TI_2308: Component adaptation pumps for SelfCookingCenter

SelfCookingCenter

05/05/2026

Old pump

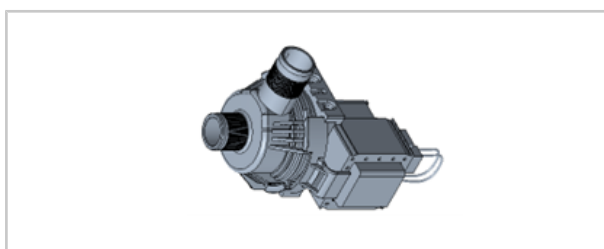
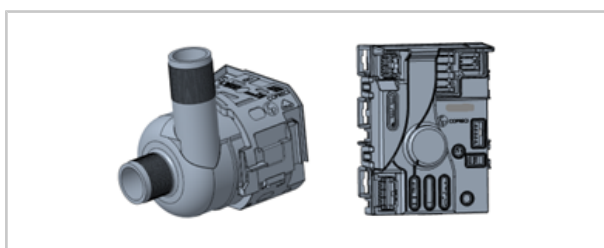
Due to a component change and in order to guarantee supply reliability, the pumps in the SelfCookingCenter (Index E-I) are being adapted.

The following table shows the assignment of the discontinued pumps to the new pumps with control electronics, retaining plates and connection cables:

Discontinued pumps			New pumps with control electronics	
Component	Article number		Component	Article number
Drain pump	44.00.207P	=>	Drain pump with control electronics	87.01.954S
Pump for cleaning UP30	56.00.153P 87.01.742S 87.00.437	=>	Circulation pump UP30 with control electronics	87.01.953S
Pump for CareControl tabletop unit	87.00.352	=>	Pump for CareControl with control electronics Table-top unit	87.01.955S
Pump for CareControl floor unit	87.00.353	=>	Pump for CareControl with control electronics Floor unit	87.01.956S

Component	Item number
Circulation pump UP30	56.01.947P
Drain pump	56.01.949P
Pump for CareControl	56.01.951P
Control electronics for pump	40.07.630P
